LIMERICK GENERATING STATION UNITS 1 & 2

DESIGN ASSESSMENT REPORT

REVISION 5 PAGE CHANGES

FIGURE 220.22-1

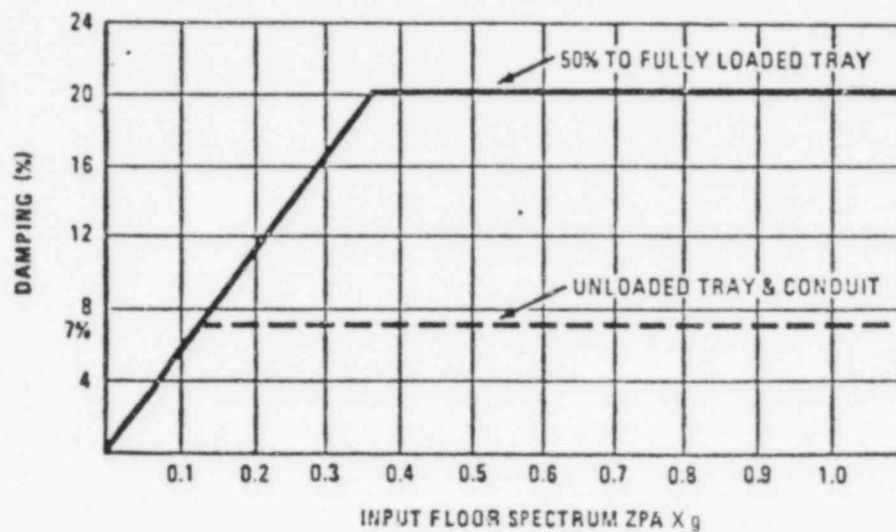
- b) In response to question 220.19 you indicated that damping values greater than 7% of critical are used. In Section 7.1.8.1 it is stated that in the analysis and design of electrical raceway system, different damping values are used for different support systems and different loading conditions. In addition it is stated that the damping ratios used for the electrical raceway assessment are in accordance with Reference 7.1-12. Provide the justification for using different damping values for different support systems and for different loading conditions and state clearly what damping values are used for electrical raceway assessment. The use of damping values greater than those specified in Regulatory Guide 1.61 should be justified.

The cable tray system damping is substantially greater than that of bolted steel structures due to the cable motion within the trays. The test program demonstrated that cable tray system damping is, in general, much higher than 10%, and damping values up to 50% were reported. The damping values recommended in Reference 7.1-12, and shown in Figure 220.22-1, are based on the lower bound values developed from the test program. An unloaded tray will have an associated lower bound damping value of about 7% as shown in Figure 220.22-1.
